Ref. Quote: 3112 / Date: 10/6/2026 / Rev 1

Project: **Sunrise Rye Brook - Independent Living / Assisted Living**

Mechanical drawings dated: 07.15.2026 (GMP set)

Mechanical Value Engineering Proposals

M2023 AL 2nd floor - DOAS corridor ducts, FSD at shaft and note for all units

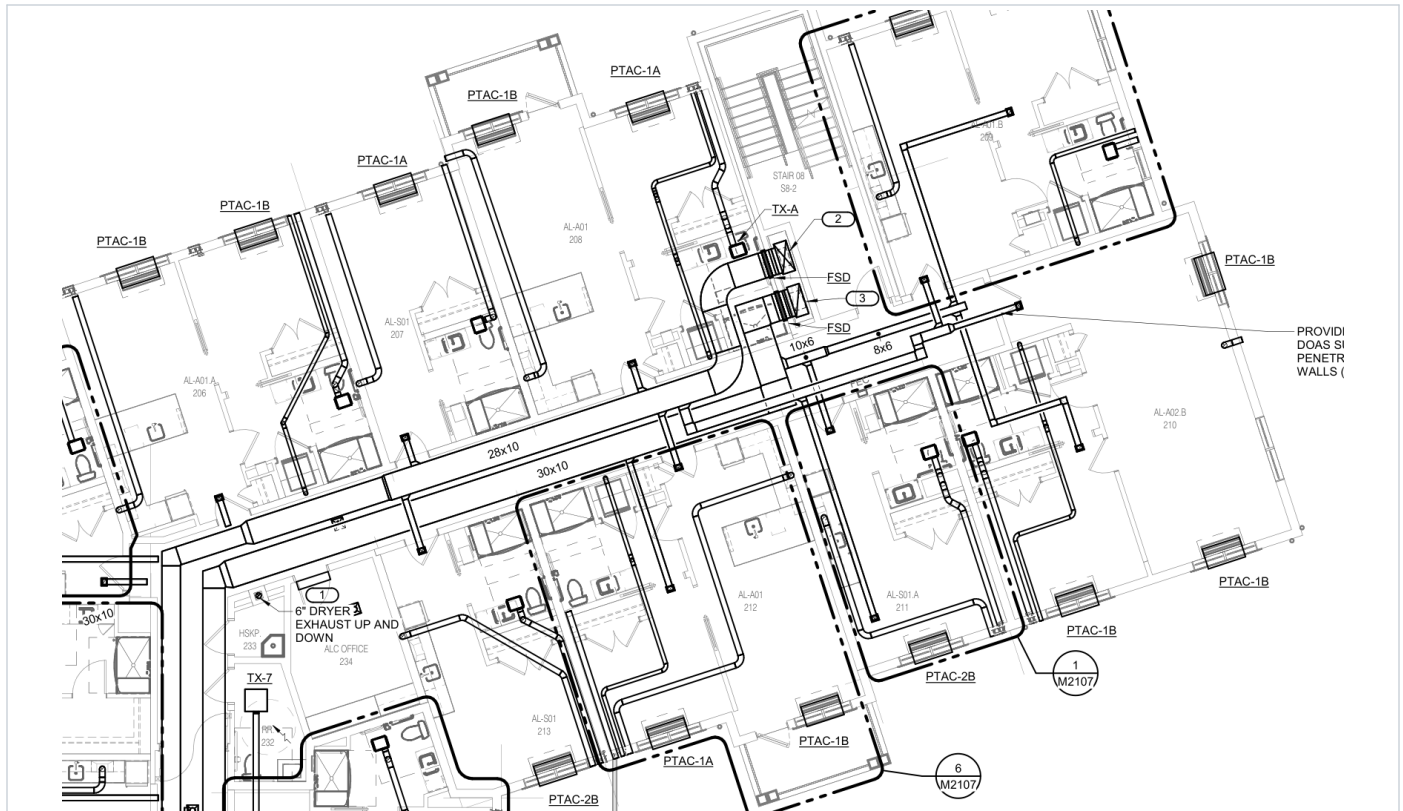
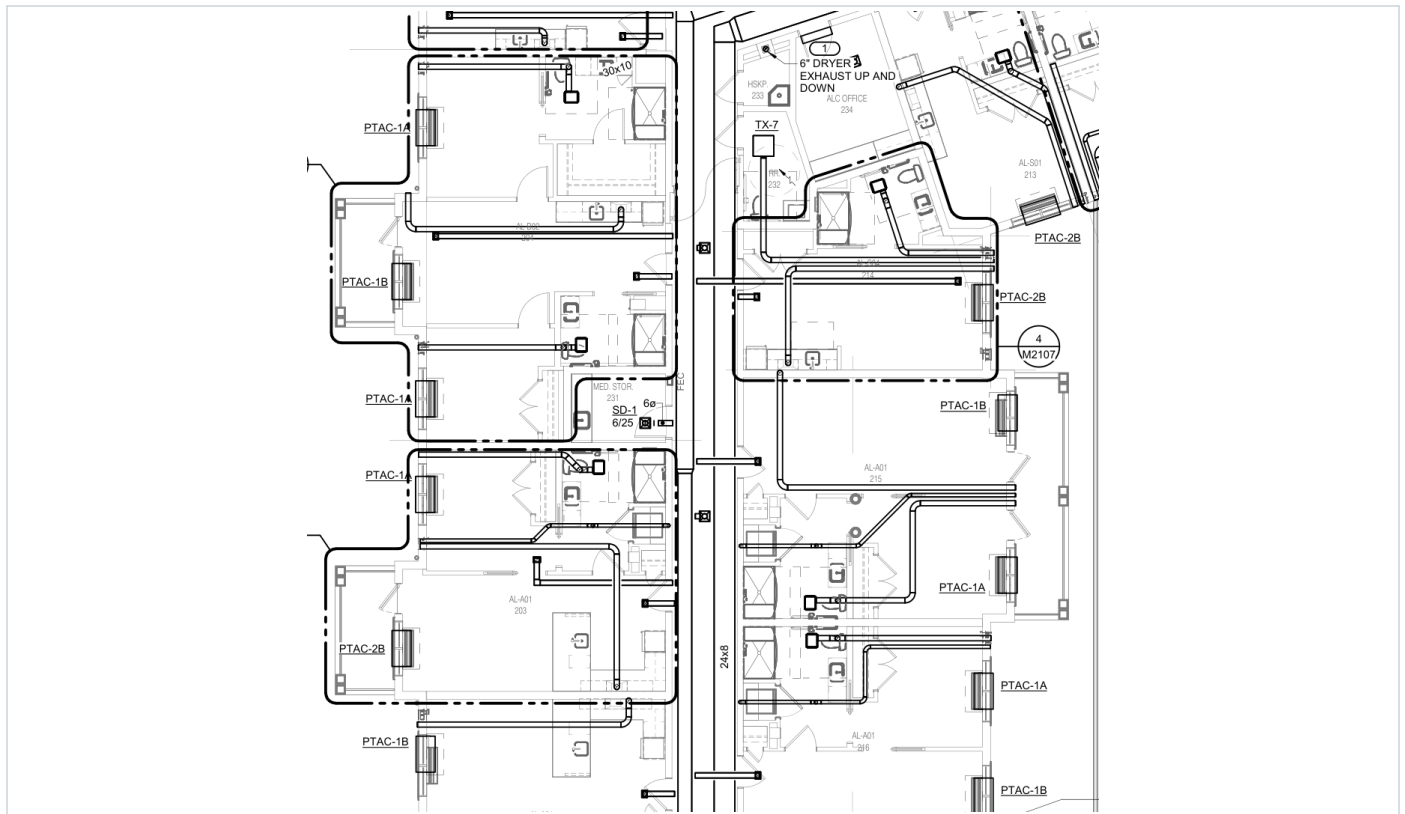
- Combination fire / smoke damper at every DOAS supply / return branch into each apartment (M2023 note: "provide fire/smoke damper at all DOAS supply/return penetrations through demising walls")
- Each damper needs power, fire alarm interface, access door in a finished ceiling and periodic testing

- Apartment branches (6x4 to 8x6) under 100 sq in, 26 ga steel, no openings into the corridor, above the ceiling, with 12" steel sleeve: no damper required at the corridor fire partition (IBC 717.5.4 exception); plain fire dampers as fallback
- Fire / smoke dampers kept at shafts and smoke barriers

M2108 AL unit plans - TX-A bath exhaust to exterior, SG-1 / RG-2 DOAS grilles

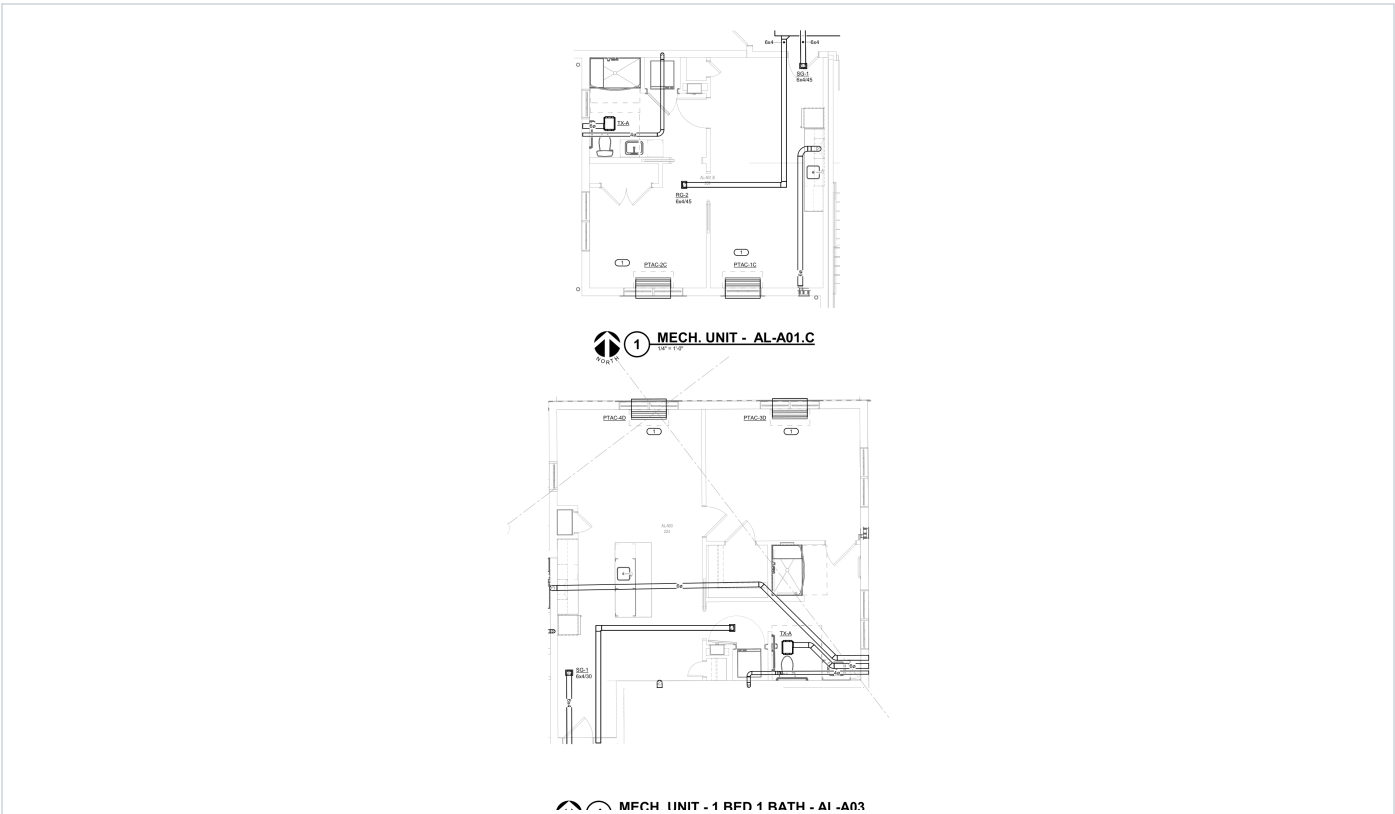
- Each apartment bath has its own exhaust fan TX-A (75 CFM) ducted out the exterior wall
- DOAS return is taken from corridors and a few rooms; some AL unit types show a DOAS return grille RG-2, the floor plans connect the return trunk to only a few (to be clarified)

- Duct apartment bath exhaust to the DOAS exhaust trunk in the corridor (as on Sunrise of Northport); the DOAS energy wheel recovers the exhaust heat
- Delete the individual TX-A fans, wall caps and their electrical circuits; delete RG-2 in the units

M5000 - BMS-controlled hydronic terminals eliminated by VE-01 to VE-05

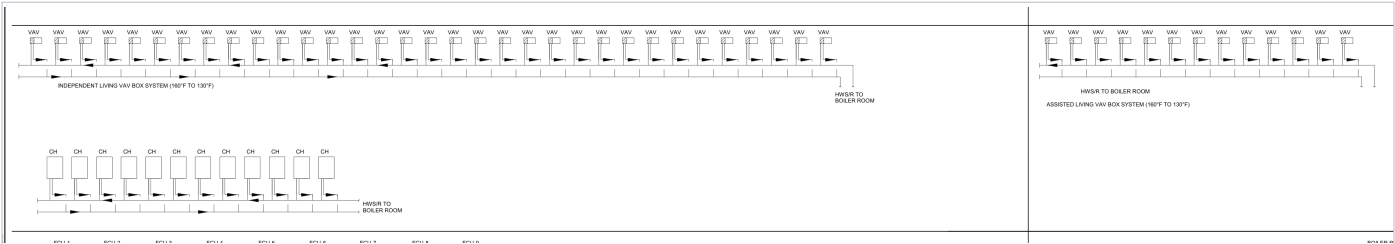
- Full BMS by the BMS contractor for boilers, pumps, heat exchangers, glycol, snow melt, VAV reheat, FCUs, cabinet heaters, rooftop units and DOAS

- With VE-01 to VE-06 the hydronic sequences (about 120 to 150 points) are gone
- Rooftop units and DOAS on their factory controls with network cards for future monitoring; heaters, mini-splits and PTACs on standalone thermostats (as on other Sunrise communities)
